Entergy Operations, Inc.
River Bend Station
5485 U. S. Highway 61
P. O. Box 220
St. Francisville, LA 70775
Tel 225 381 4374
Fax 225 381 4872

Subject: River Bend Station
Docket No. 50-458
License No. NPF-47
Supplement to License Amendment Request (LAR) 1999-30, "IFTS Blind Flange"

IFTS Designated Operator Dose Evaluation

Figure 1

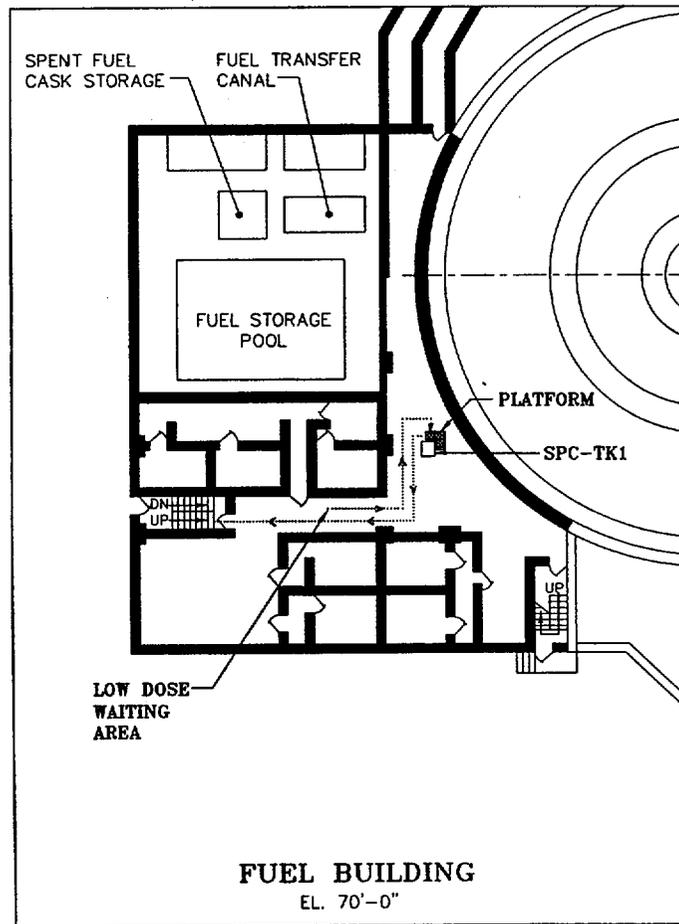
2. The operator will be staged in a low dose waiting area near the IFTS drain tank. The normal operation background dose rate is generally ≤ 2 mR/hr. The two isolation valves are accessible on the platform at the end of the tank itself. The staging area is denoted on the figure 1 below.

4. Upon isolation, the operator will egress the area by proceeding north, climbing the stairs, and exiting the Fuel Building through the door located roughly at lines plant FE and 5 (USAR Figure 1.2-20) and finally proceeding to either the Technical Support Center, the Main Control Room, or the exiting the plant entirely as directed by Operations. Figure 1 below shows the pathway within the fuel building.
